Technical Service Information

THM 4L60 (700-R4) PUMP MODIFICATION TO ALLOW INTERCHANGE

Figure 1

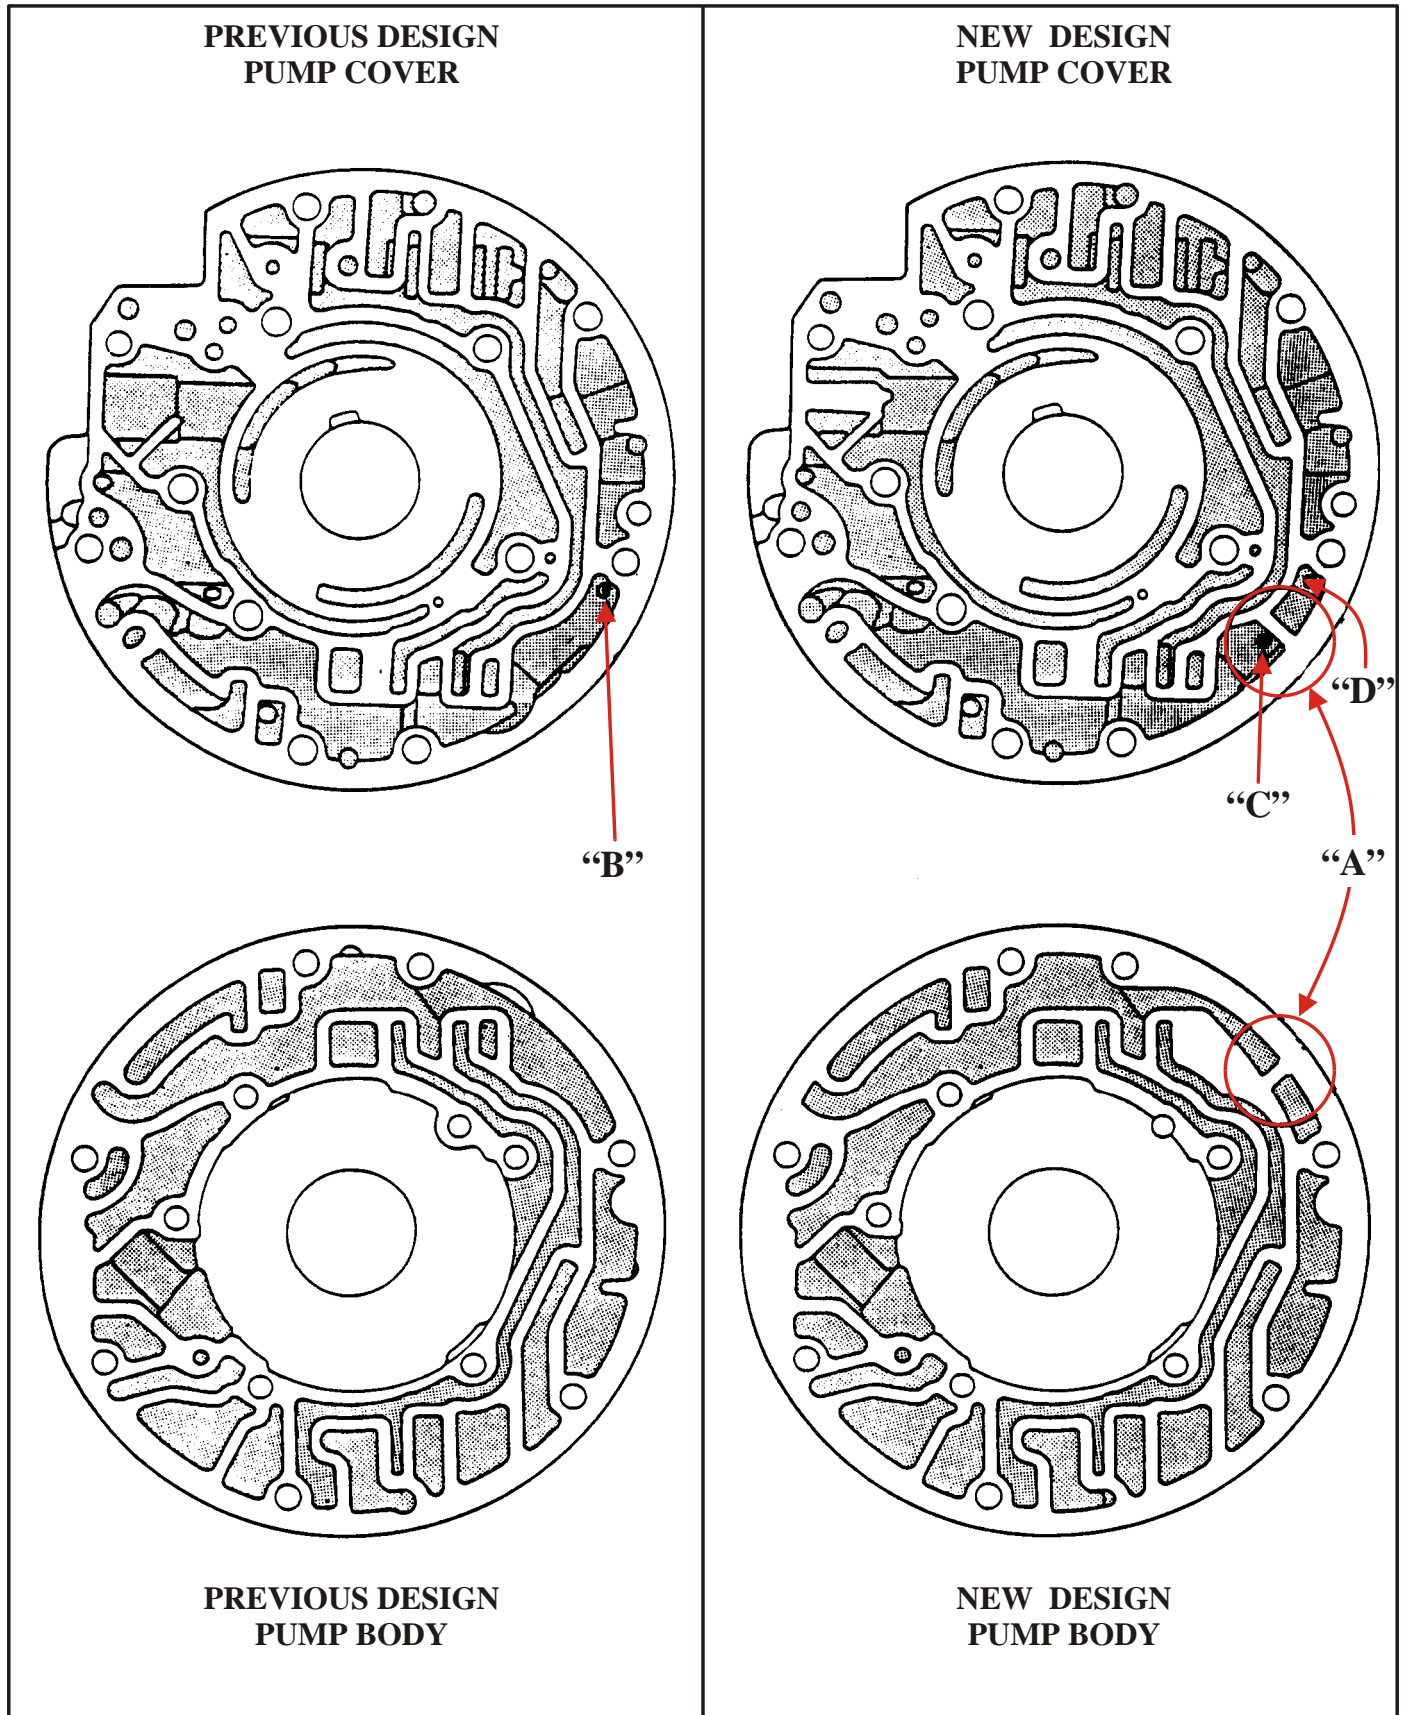
In June of 1984, all models of the 1984 THM 700-R4 transmissions were built using a new pump assembly. This pump change is also used on all 1985 700-R4 transmission models. This new pump assembly has a dam added to the line pressure passage, and the casting around the perimeter of the pump was made thicker so as to reduce fluid leakage and cross leaks between the pump cover and pump body (See "A" Figure 1). The cross leaks were sometimes bad enough to create a "moaning" sound from the pump area.

In the line pressure passage of the previous pump cover casting they installed a air bleed in the form of an orificed cup plug (See "B" Figure 1). In the line pressure passage of the new pump cover, they installed the air bleed just inside of the added dam (See "C" Figure 1).

With the addition of the dam, the area just outside the dam became a void, so there was no longer a need to install the orificed cup plug, and if you used it that way with the early pump body, you would indeed have a loss of line pressure.

If you will tap the hole (See "D" Figure 1) with the appropriate size tap and install a recessed allen pipe plug with lot-tite, the late pump cover can be used very successfully with the early style pump body and you save yourself a healthy piece of change. Try it, it works.
